Kienstra Copy.pdf

PROJECT Webster Univ
SUBJECT MH 22
CUSTOMER Castle
DATE SUBMITTED BY BH
CHKD SHEET NO. OF

WEBSTER UNIVERSITY ISB
PROJECT NAME

RE: Precast Storm Structures

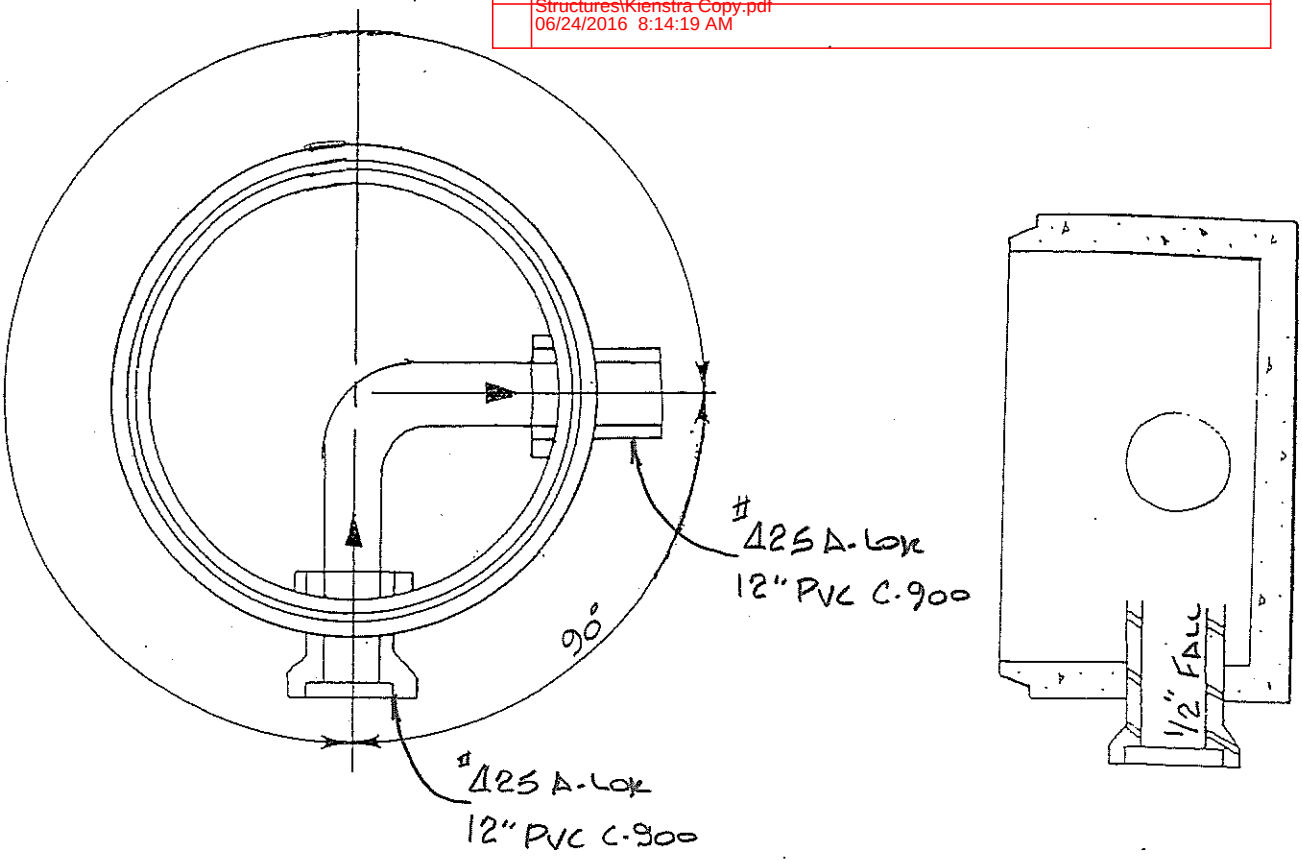
Please advise if there are any additional comments for manhole 22, which is within the building.

The Top of MH 22 is 541.50. It had been rounded up to this from 541.49.

For Manhole 22 please provide rubber gasket between cover and frame.

SUBJECT MH 27

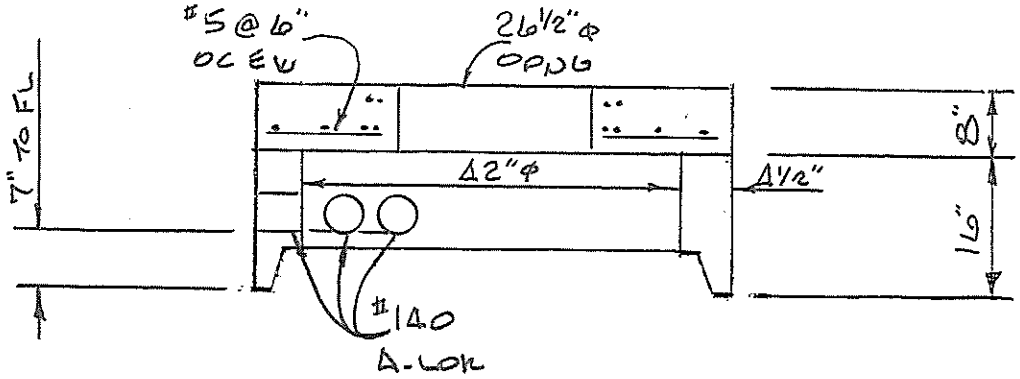
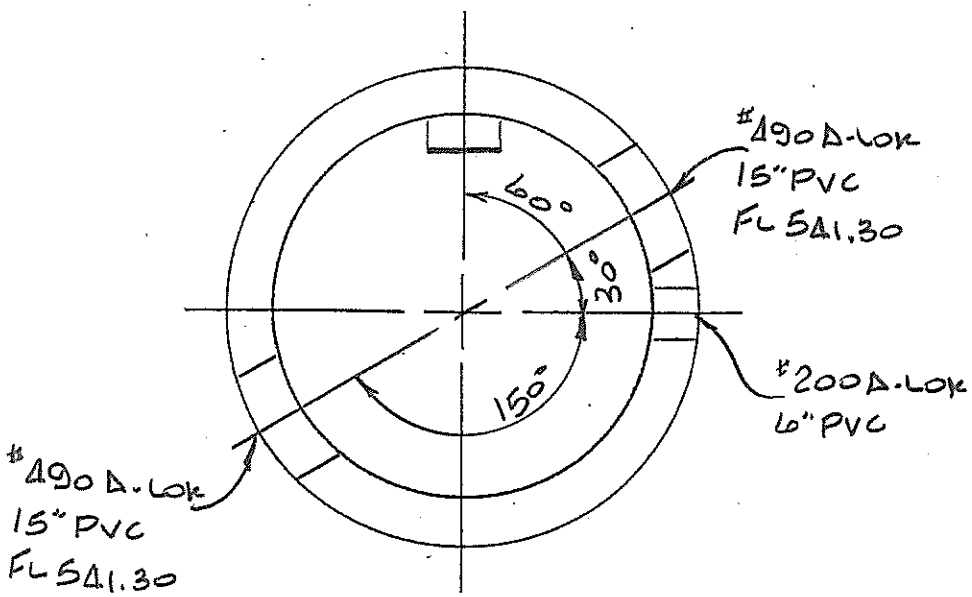
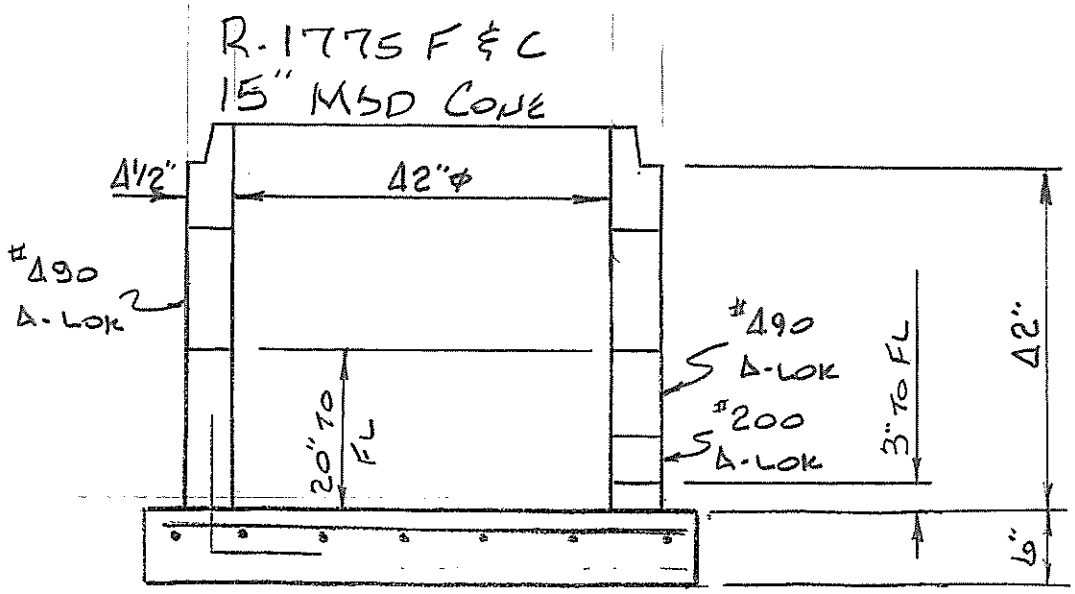
Check with MSD and ask if they need to review structure 27. Although it does not house the downstream defender it is a part of the system.
